AMENDMENT NO. 10 July 1980

WASHINGTON PUBLIC POWER SUPPLY SYSTEM NUCLEAR PROJECT NO. 2

FIGURE 7.6-1b

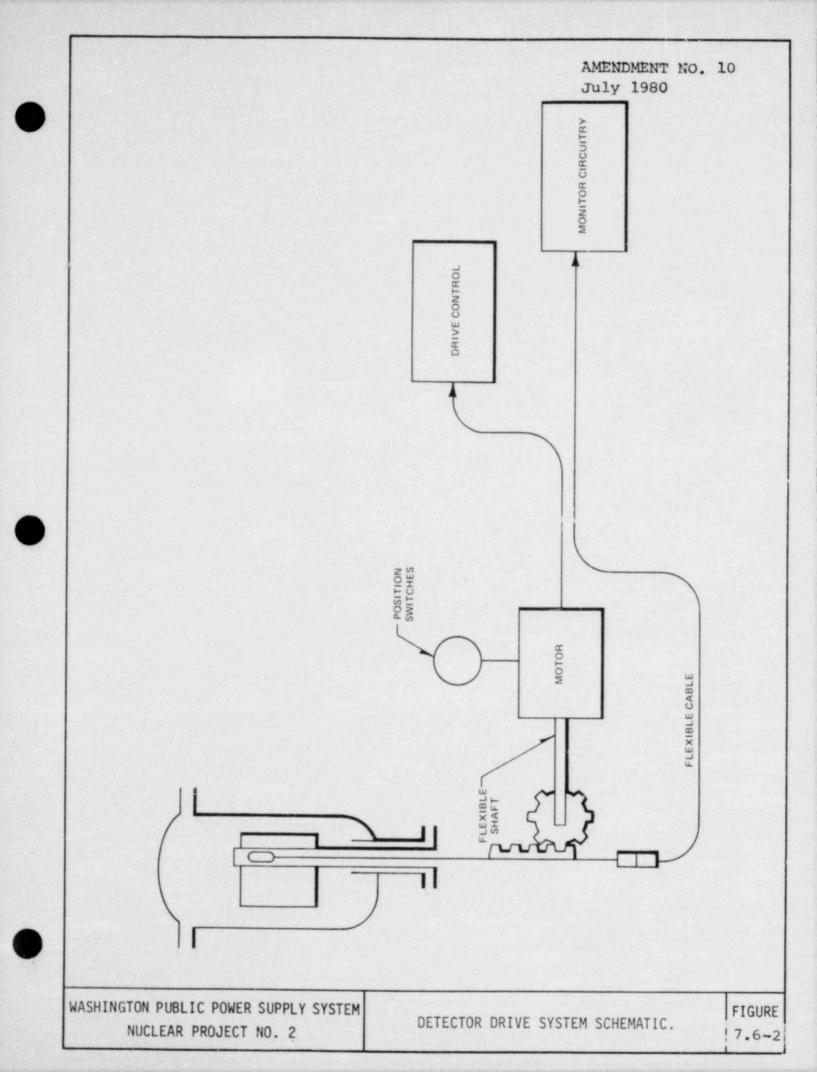
Clarify the discrepancies between the following sections and figures of the FSAR with regard to isolation of the reactor water cleanup system when the standby liquid control system is initiated: (1) Sections 6.2.4.3.2.1.1.7, 7.7.1.3, 7.6.1.4.3.6, and 9.3.5.2; (2) Figures 7.3-11a, 7.4-3, 7.7-14, and (3) Table 7.3-13.

Isolation of the RWCU system by SLCS initiation is not described in 6.2.4.3.2.1.1.7 and 7.6.1.4.3.6 or in Figure 7.3-11a because these sections and figure discuss provisions for assuring primary containment integrity following a RWCU system line break outside the containment. RWCU trip with SLCS initiation is provided, not to assure containment integrity, but to assure proper operation of the SLCS and is, therefore, only discussed in 9.3.5.2 and shown in Figure 7.4-3 as part of the SLCS system description.
